Subject: Site plan and plan of operation for a new retail business (Dollar General) located at northeast corner of Godfrey Lane and CTH NN (EGLT1818999021); The Overland Group (Jacob Stauffer, agent and Joe Mayer, consultant)

Application: 2020-17; <https://s.zoninghub.com/U6GWBGL6EG>

**RE: Dollar General Store
Preliminary Plan Review for Dollar General
Eagle, Wisconsin**

A2.1
EXTERIOR
ELEVATIONS

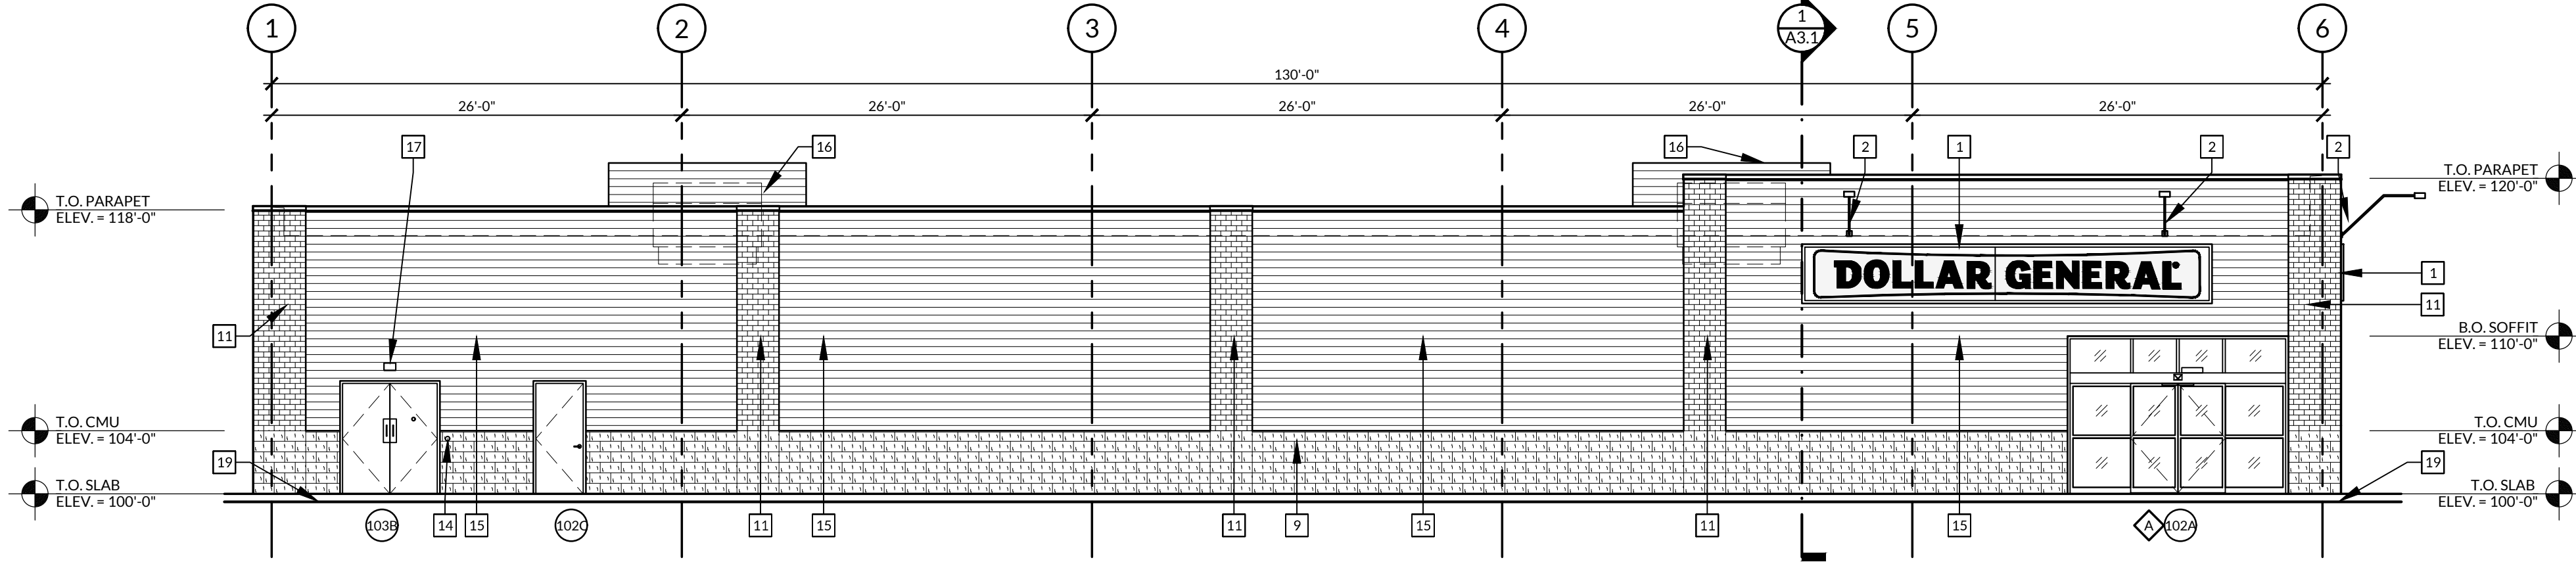
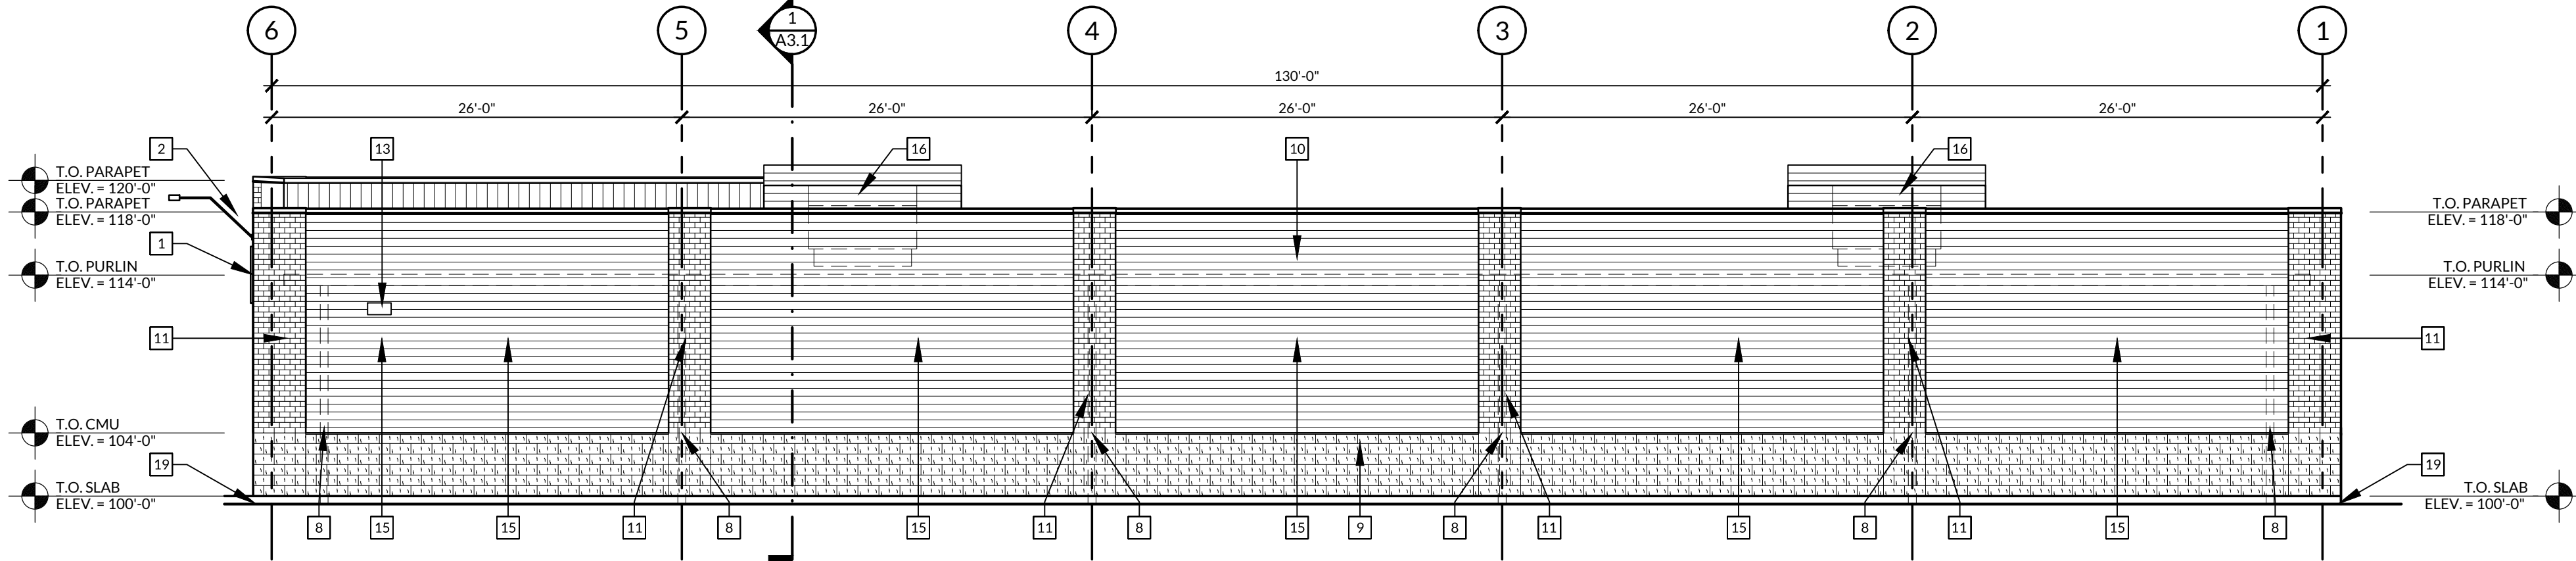
1. Provide Masonry building materials on the east elevation.
Response: All four elevations of the building are now masonry – see revised elevations.
2. Provide pilasters on the east elevation to break up the façade.
Response: Vertical elements and pilasters have been provided on the revised building elevations.
3. Provide a parapet wall on the east elevation.
Response: A parapet wall has been provided on the east elevation. – See revised elevations.
4. Provide 8" deep by 12" wide pilasters per Town Code.
Response: The necessary depth and width of pilasters has been provided – See Site Plan.

5. Move the entry door on the west elevation to encourage parking on the west side of the building.
Response: The entry door has been moved to the west elevation – See Site Plan.

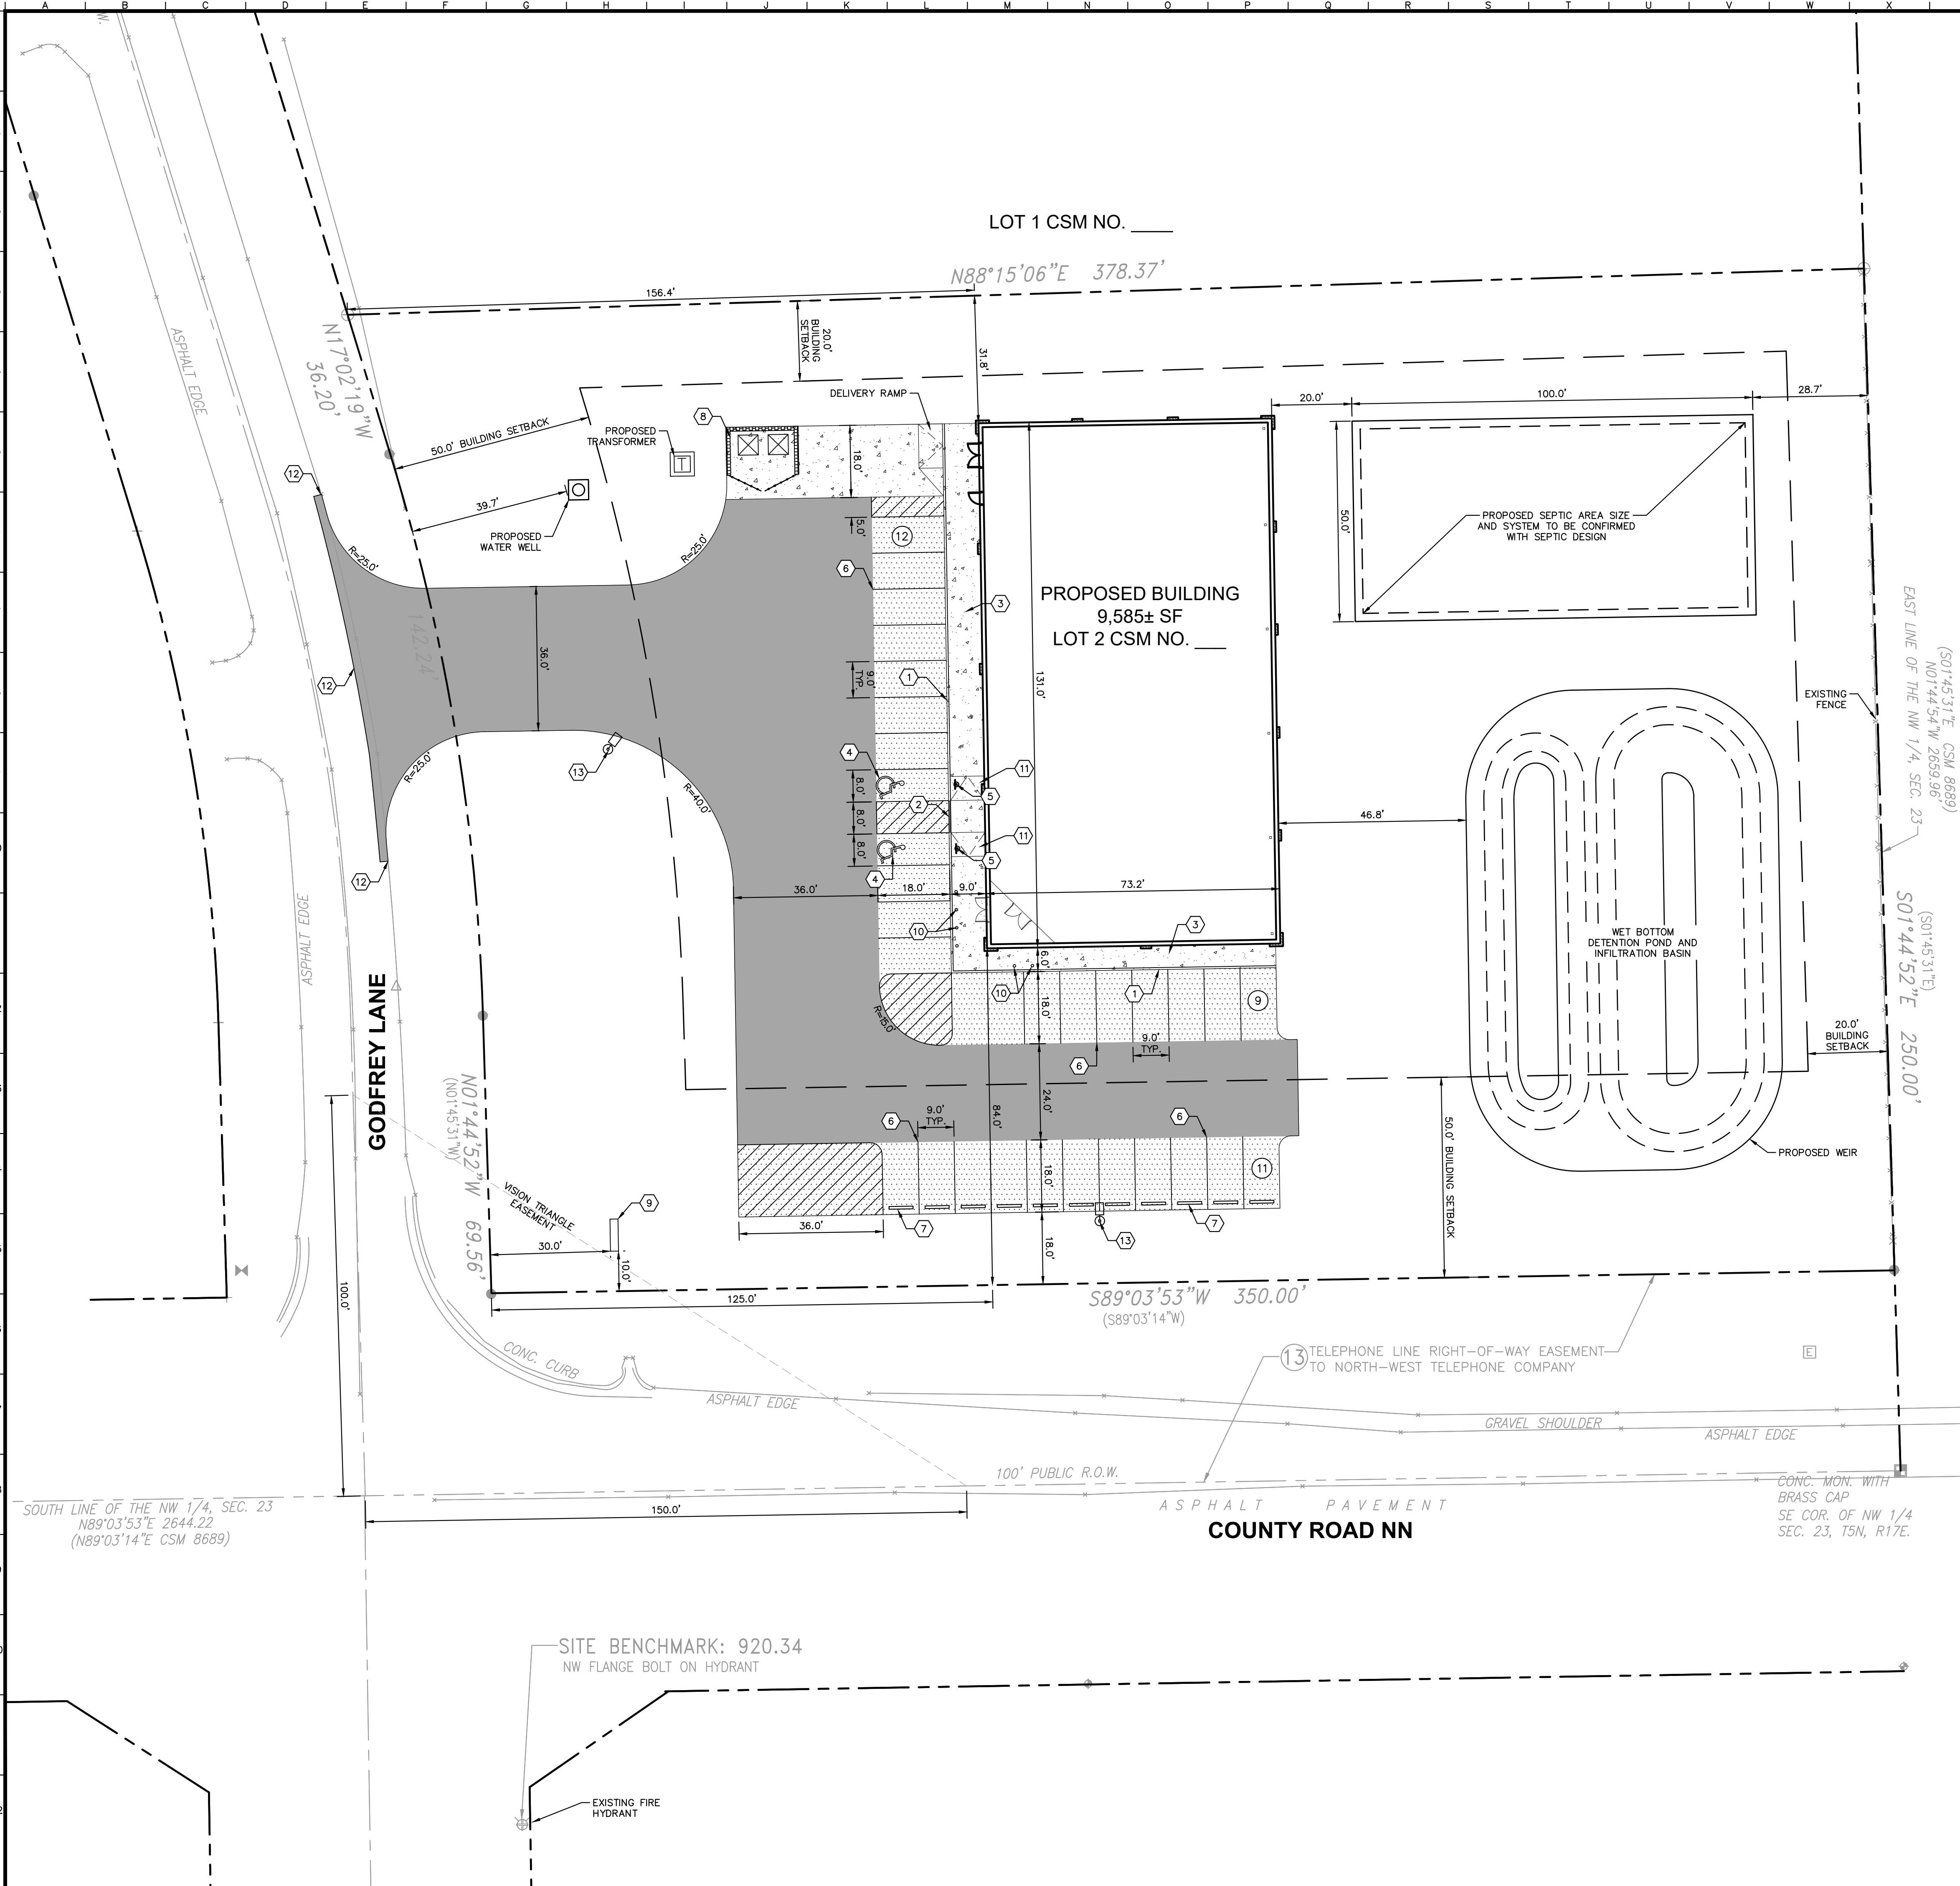
14. Note 12 in the utility notes state light poles are shown. Please add light pole locations to the site plan.
Response: Light poles and their locations have been added to the Site Plan (C3.0) and Utility plan (C6.0).

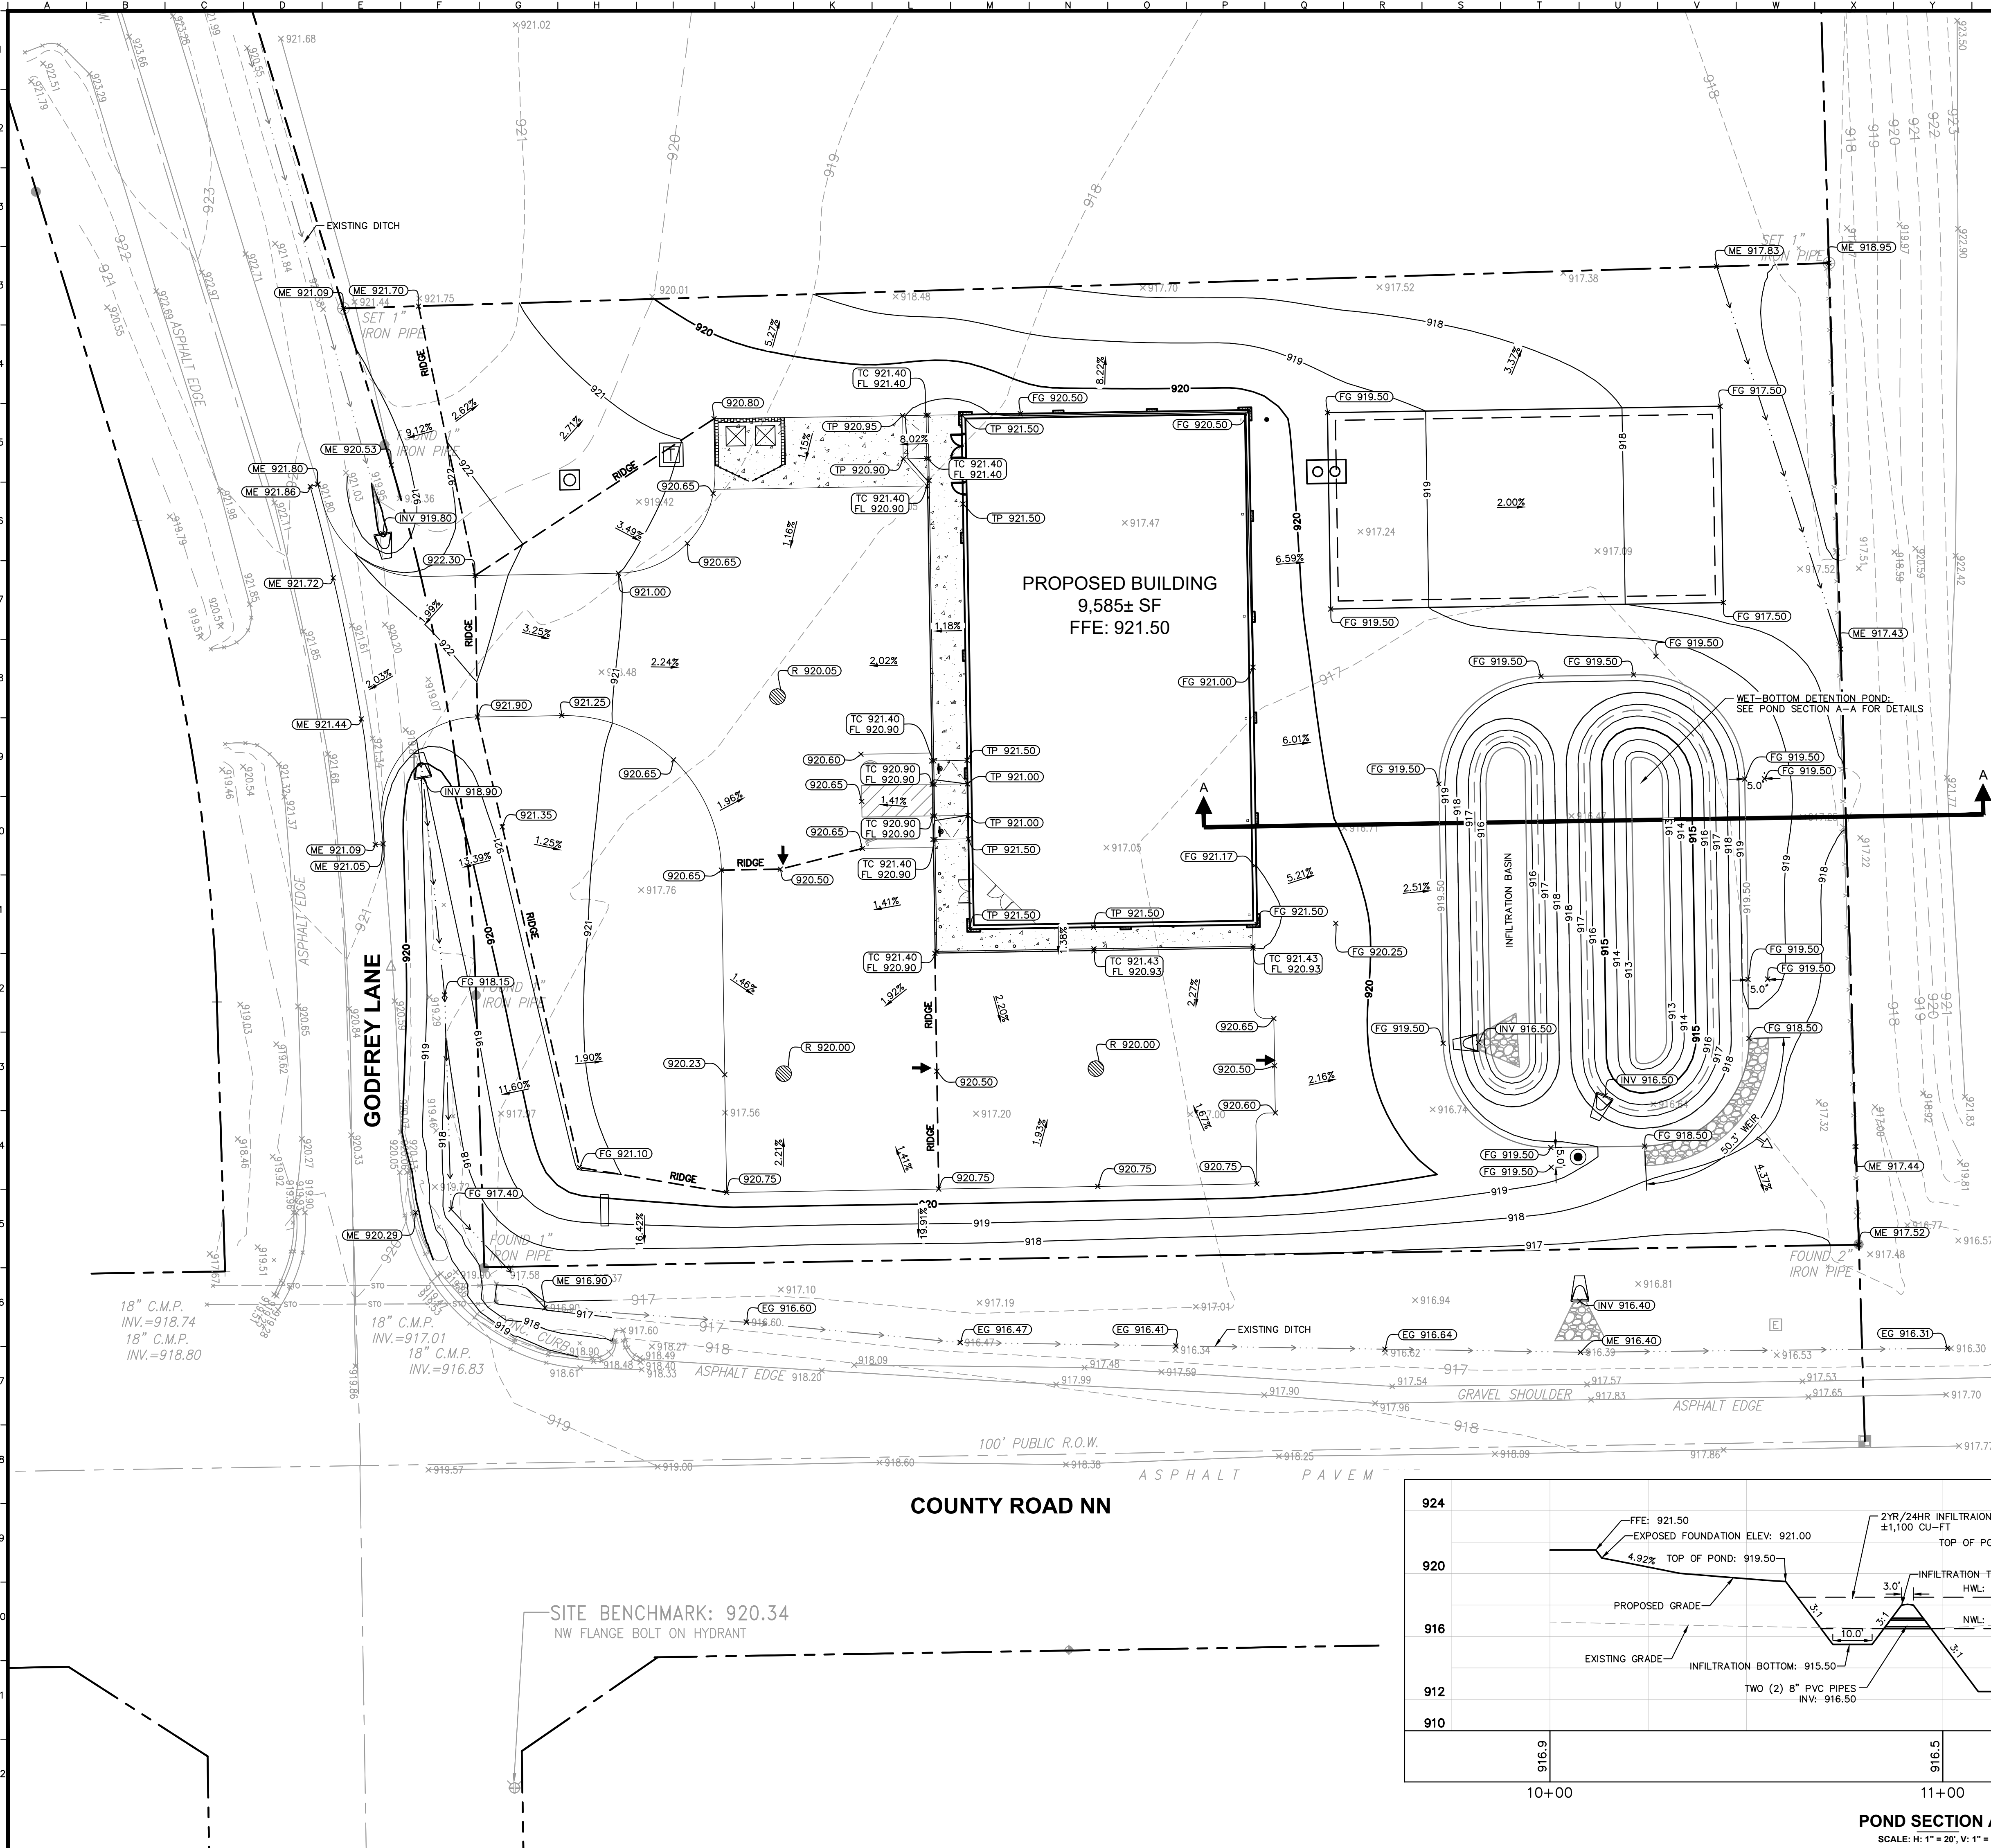
Response: Pavement sections for asphalt and sidewalk have been included on sheet C7.0.
2. Verify the building FFE. The plan elevation and cross section elevation are different.

Response: The FFE is 921.50, which has been corrected on the Plan and Cross Section on Sheet C5.0.
3. The top of curb and flowline elevations appear to be reversed along the front edge of the walk.

Response: Top of curb and flowline elevations have been revised to show correct values. See Sheet C5.0.
4. Label proposed pipe with pipe diameter, pipe type, and length on C2.0.

Response: Sanitary and storm pipes have been labeled accordingly, see Sheet C6.0.
5. The sidewalk along the building is less than 1% in slope and the slope should be increased to provide better drainage away from the building.

Response: The proposed sidewalk grades along the building have been revised to increase the slope to a value greater than 1%, but less than 2.0%. See sheet C5.0.

6. The drainage away from the rear of the building does not meet requirements of SPS 321.12.
Response: The drainage away from the rear of the building has been increased above 0.5" per 12" (4.167%) for at least the first 10 feet. See Sheet C5.0.
